Date: March 06, 2014
To: Coiltronics DRA Series Inductor Customers
Subject: Product Change Notice – Reactivation of Select Part Numbers

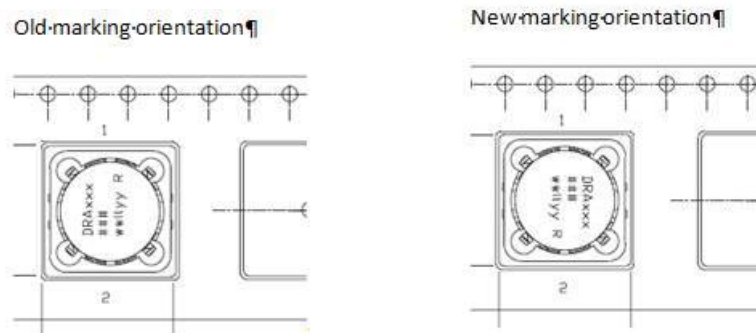
2. DRAs part marking orientation change example showing as below
